TREE LOCATION PLAN
CROSS STREET, WORSBOROUGH S70
NOT TO SCALE. JUNE 2026

Photograph 8.

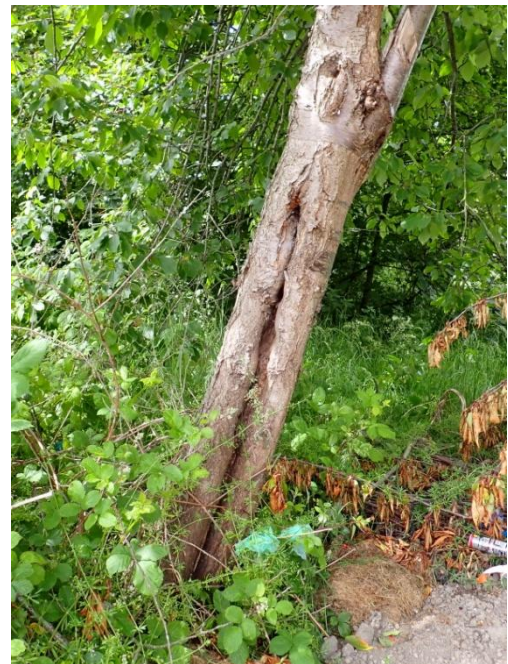
While the proposal shows all these trees retained, there isn't much that is worth retaining in group 4.

Photograph 8 is a view of the trunk of the Cherry tree in group 4, which is damaged and decayed. The Holly tree in the group is also almost dead.

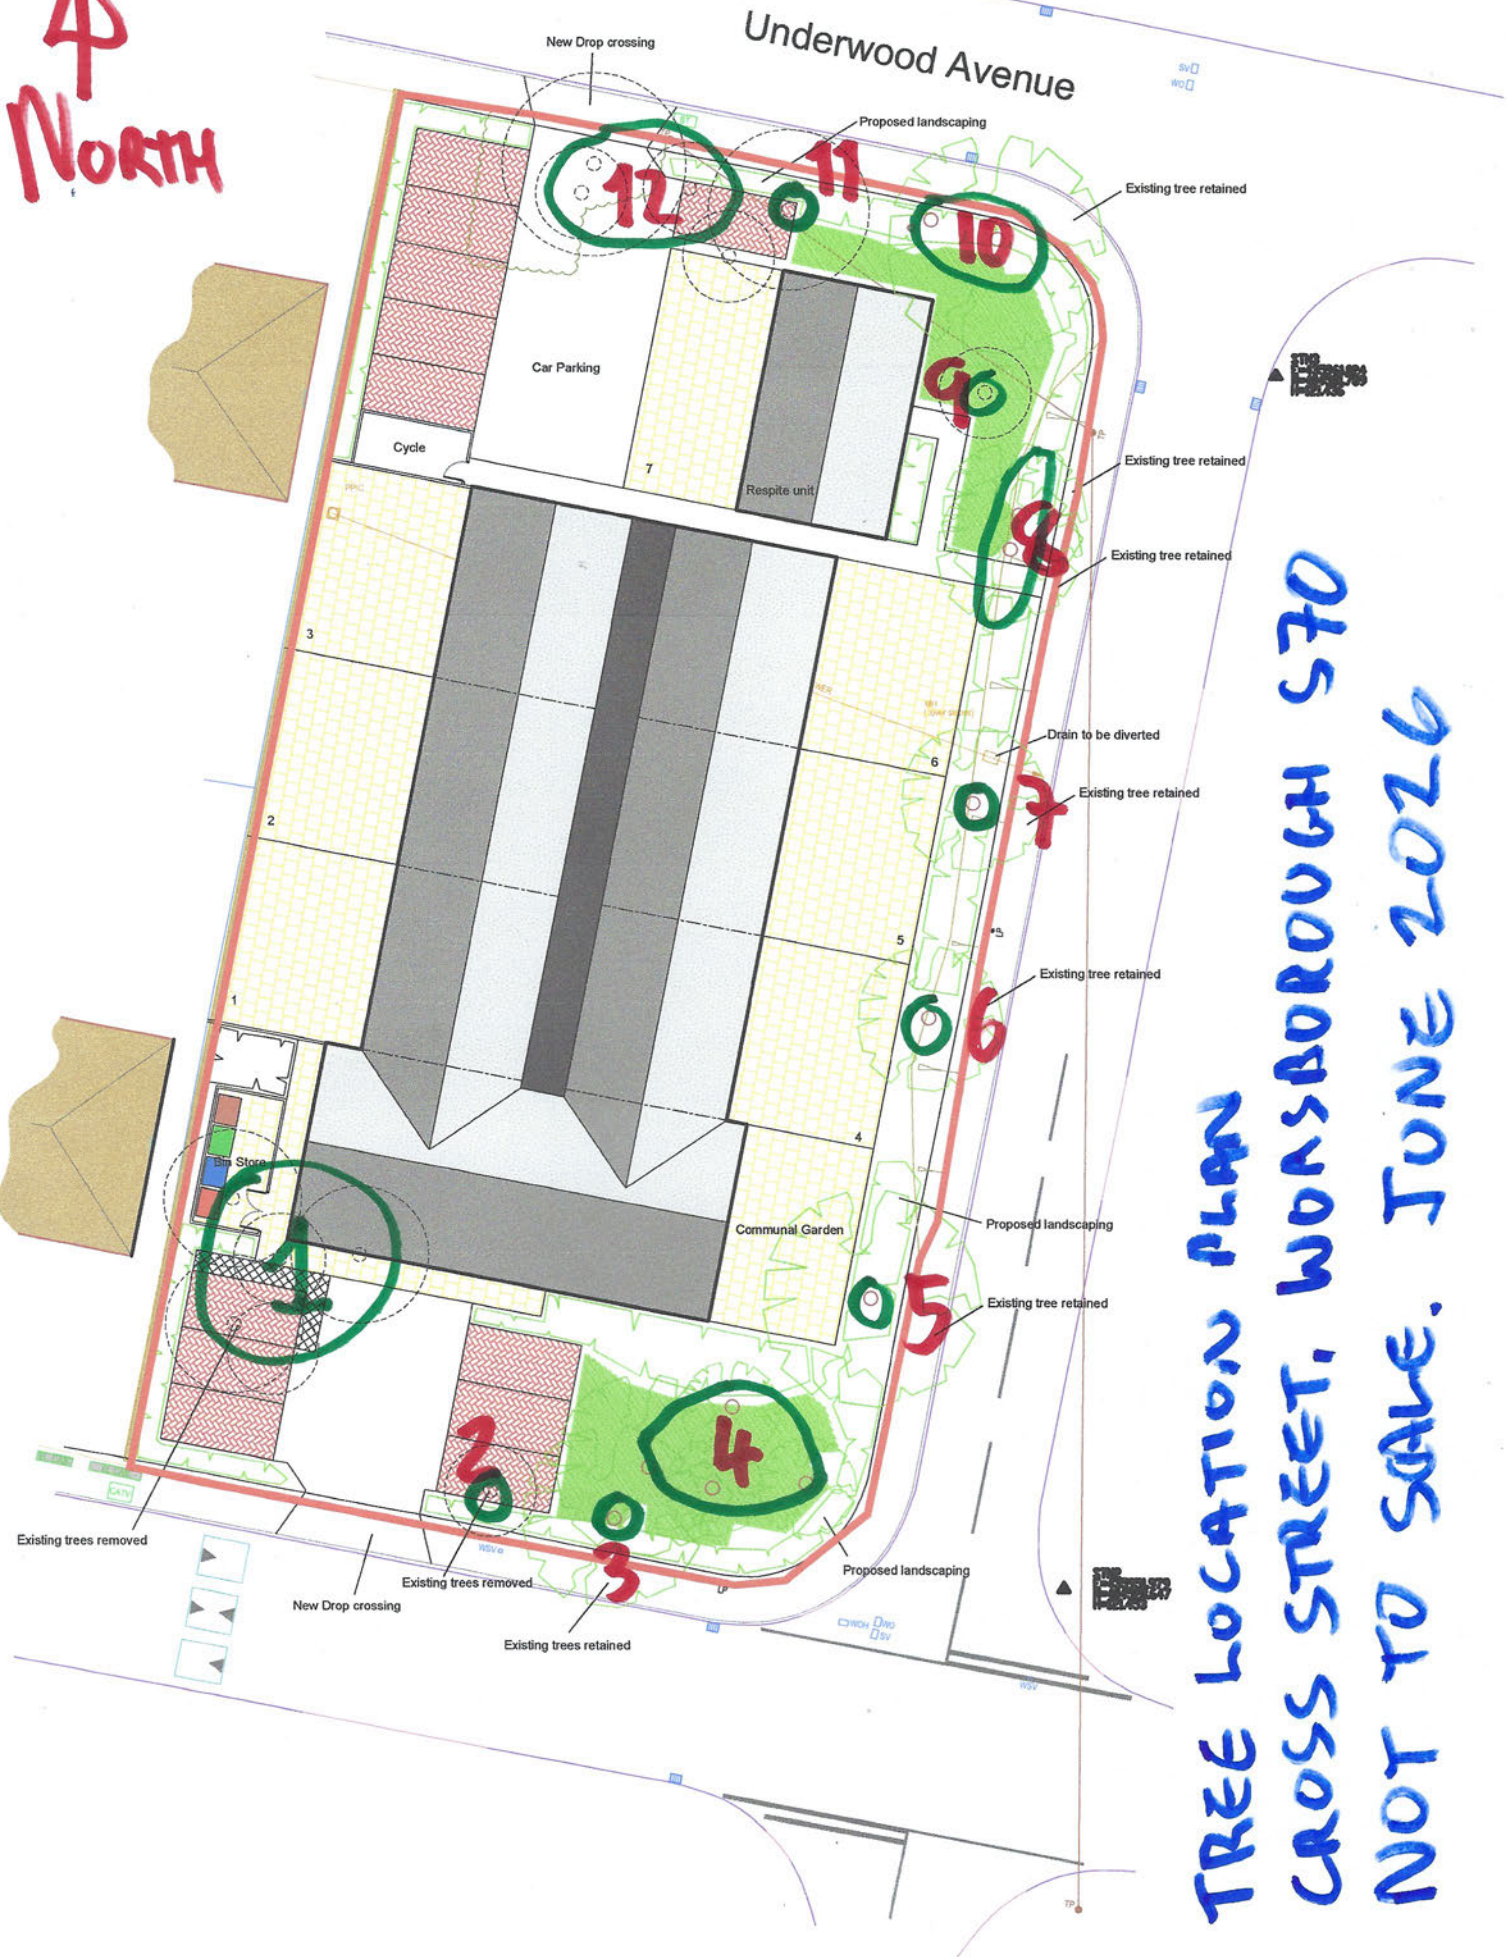
Taking the above into account, my advice is that the best way of ensuring that this site makes a contribution to the local landscape in the future is to remove them all and replant when development work is over. I don't think we can avoid the fact that nearly all the trees are already compromised by ground works and susceptibility to disease (the Ash) so the best option is to remove and replant.

In my opinion planting the site with Hornbeam trees in place of 4, 8, and 10 would be pragmatic, perhaps with mixed (native) hedging along the boundaries. Hornbeam is a native species and grows well in urban areas. It is also not particularly disease prone and the Forestry Commission website does not have any alerts about impending diseases. Mixed native hedges are much more desirable than Privet or Leyland Cypress and invariably prettier as well.
